# Caldecote PC Working Party EWR Summary

## 1) **AGAINST** - North Cambourne Station - Alignments 1(Blue) & 9(Purple)

Figure 1 Route of Alignments 1&9 through Highfields

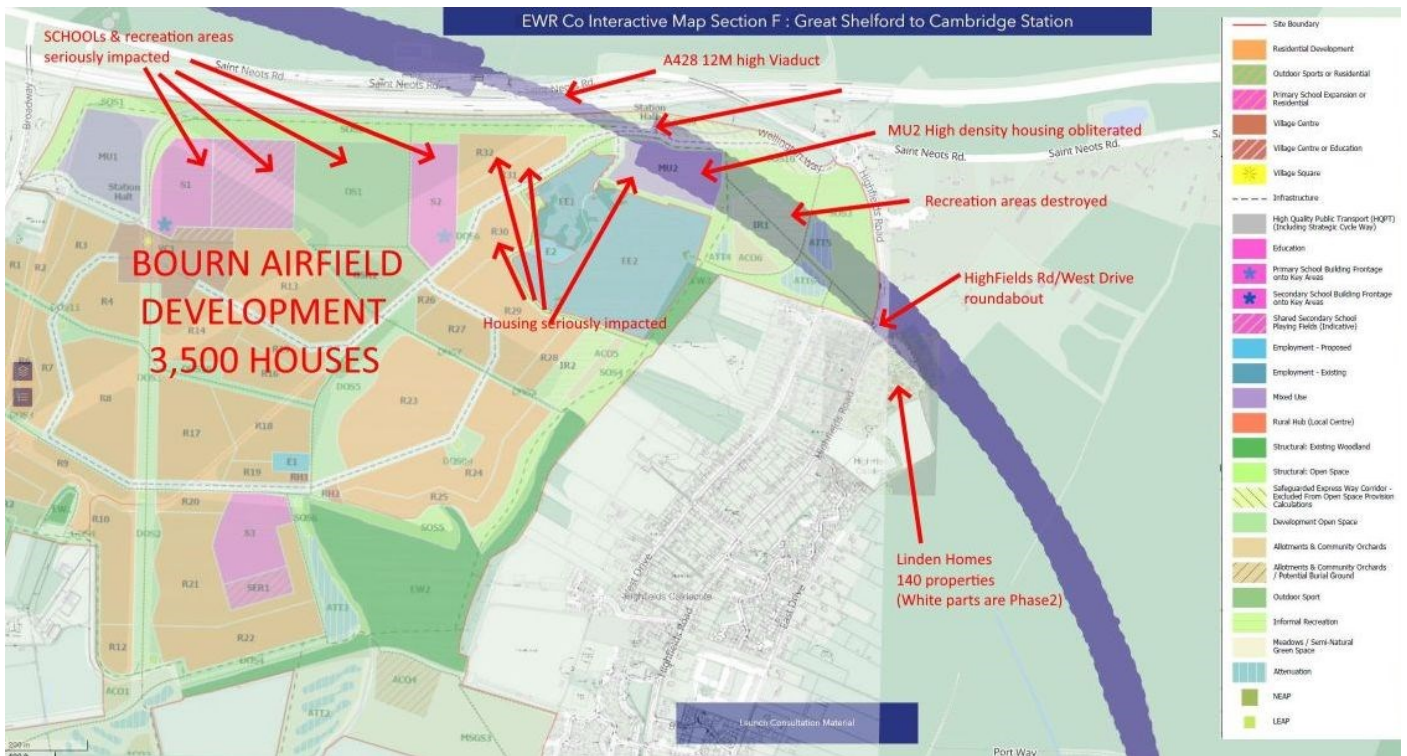
iii) No real account has been made to the pollution, noise and visual impacts on the inhabitants of West Drive, Highfields Road, Highfields Court of a 12m high 80M+ wide embankment, or the possibility of severance further down towards Hardwick and Toft/Comberton. No-one needs reminding that this is a route to our village college.

- *Having to rise up an additional 12 meters on a hill that is already some 72M high has a disproportionate visual, noise and pollution impact on the surrounding area.*

iv) No account has been made for the severance of the entrance of Highfields and its main access to the old A428.

- a) Due to the proposed height and its impact on 2 communities the only sensible mitigation would be to tunnel under the A428.
- b) Across the field it should be in a cutting below ground, just as is offered to the Broadway on alignments 2 & 6. This should extend to behind the woods at the back of Angel Park.
- c) Where it cuts Highfields Road and the track to Highfields Farm & its Public Right of Way there should be bridges constructed over the cutting at ground level.
- d) Pedestrian and cycling access should be offered by similar bridging across the field as per the paths detailed by the approved Bourn Airfield Development plan
